# UNITED STATES PATENT AND TRADEMARK OFFICE

APPLICATION NO.	FILING DATE	FIRST NAMED INVENTOR	ATTORNEY DOCKET NO.	CONFIRMATION NO.
10/732,970	12/11/2003	Theodore W. Houston	TI-35974	8532

<b>Office Action Summary</b>	<b>Application No.</b> 10/732,970	<b>Applicant(s)</b> HOUSTON, THEODORE W.	
	<b>Examiner</b> TRONG PHAN	<b>Art Unit</b> 2827

## **DETAILED ACTION**

FIG. 5

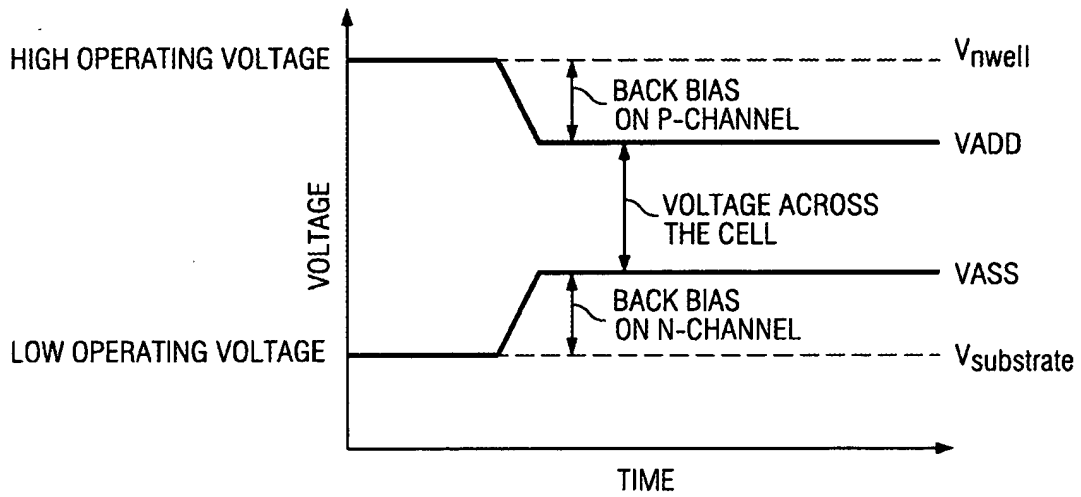
Newly added Fig. 5 was not described in the original specification, therefore, it constitutes a new subject matter. It should be noted that new Fig. 5 shows the voltage across the cell clearly higher than the back bias on p-channel and also higher than the back bias n-channel; and the low operating voltage is clearly the same as the  $V_{\text{substrate}}$ .

g) newly added Fig. 5 constitutes a new subject matter;

DISAPPROVED  
TP  
9/19/06
